Office Action Summary

10/748,857

CORNFIELD, RANDALL

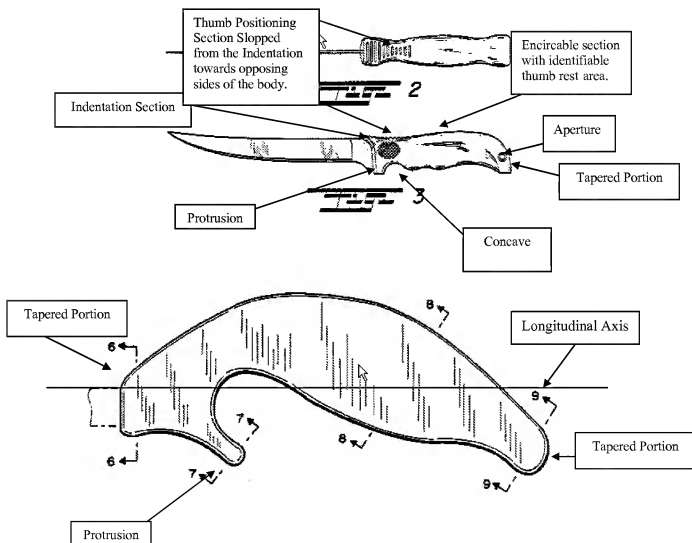
Regarding (1)-(3), Mosley teaches these general concepts in a particular handle design. Such a design creates a particular visual appearance that may be desired. In addition, one skilled in the art would know that the particular indentation shape provides additional shielding to the finger of a user. It would have been obvious to include such modifications in the design of Herron for the

purpose of achieving a particular visual appearance of the handle as well as additional shielding means for a user's finger during use of the knife.

Applicant argues that Herron does not provide a thumb positioning section with a concave indentation and the thumb positioning section sloping downwardly from the indentation towards the opposing side of the body. The examiner disagrees, since such limitations can be read into the figure of Herron. See above attached figure. Looking closely at both figures 2 and 3, Herron can be interpreted to provide at least a minimum amount of sloping from the thumb position section to opposing sides of the body (note the lines in the drawings used to represent curved regions, as conventional in mechanical drawings and the like). Applicant has not sufficiently amended the claims to overcome the applied art of record.
